10GBASE-CX4 Link Analysis Outline

Cable Assembly Summary / Recommendations

Cable Assembly Return Loss Sensitivity

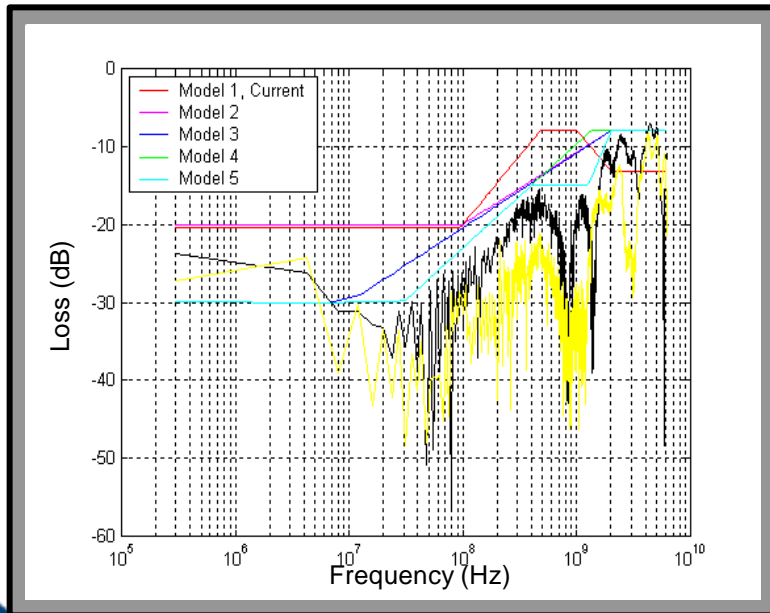
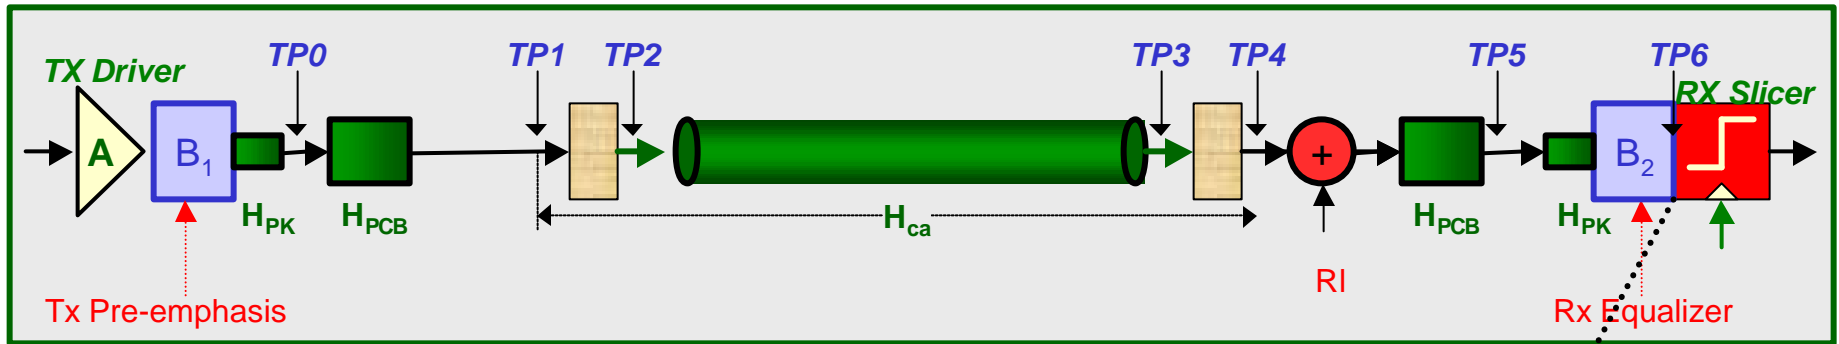
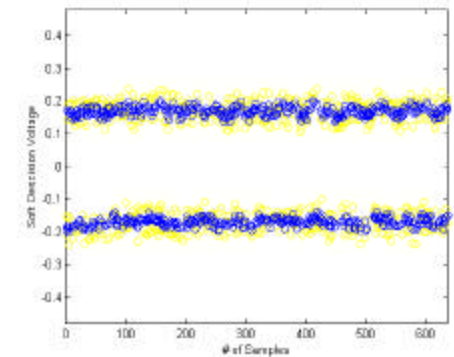
Model	Eye	Margin
1	171	96
2	176	117
3	175	115
4	161	100
5	205	243

Model 5
 Eye = 262mVpp
 Margin = 202mVpp

- MDEL_{Fext} is too large and doesn't match measured cable assemblies, change to:
 - $MDEL_{Fext} \geq 15 - 21.85 \times \log_{10}(Freq/50)$ for $50MHz < Freq \leq 2000MHz$
 - $EL_{Fext} \geq 17 - 21.85 \times \log_{10}(Freq/50)$ for $50MHz < Freq \leq 2000MHz$
- Return Loss is too large and doesn't match measured cable assemblies, change to:
 - $Return\ Loss \geq 30 - 13.33 \times \log_{10}(Freq/30)$ for $10MHz < Freq \leq 400MHz$
 - $Return\ Loss \geq 15$ for $400MHz < Freq \leq 1250MHz$
 - $Return\ Loss \geq 15 - 34.3 \times \log_{10}(Freq/1250)$ for $1250MHz < Freq \leq 2000MHz$

D4.1 Cable Assembly Model?

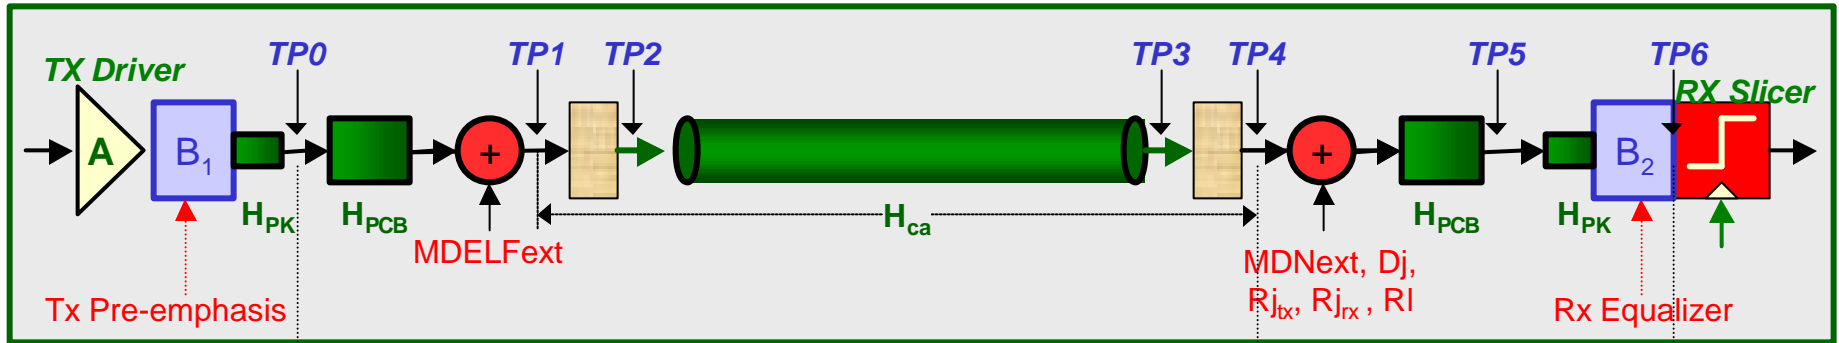
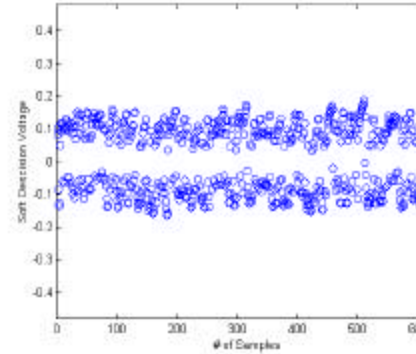
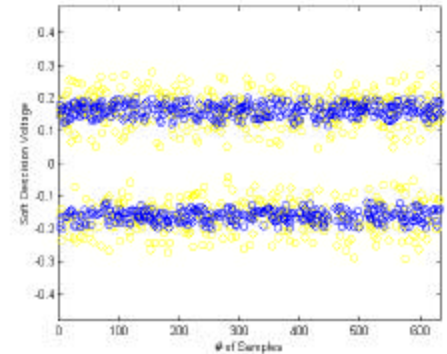
Eye = 400mVpp
Margin = 400mVpp

Eye = 38mVpp
Margin = -17mVpp

Eye = 86mVpp
Margin = -3mVpp

• Typical Eye Diagrams for Nominal Pre-emphasis = 36%
